## Safety Notice

170017

**Model Number:** S-60  
S-65  
S-80X  
Z-80/60

**Subject:** Oscillate Cylinder Counterbalance Valves

Oscillate Cylinder Locations

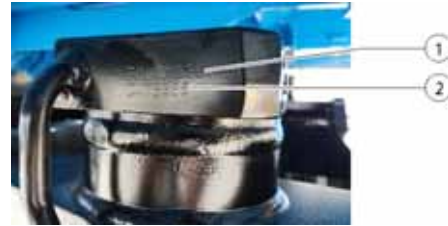
Genie has been informed by a supplier that the counterbalance valves in the oscillate cylinders installed on the machines referenced on page 3 may have been improperly calibrated. **Improper calibration of the counterbalance valve can lead to machine instability resulting in a machine tip over.**

- 1 Locate the affected machines referenced above within your fleet and remove from service.
- 2 Locate the oscillate cylinders and inspect for the cylinder serial number (2 per machine).

Note: Perform this procedure on a firm, level surface with the machine in the stowed position.
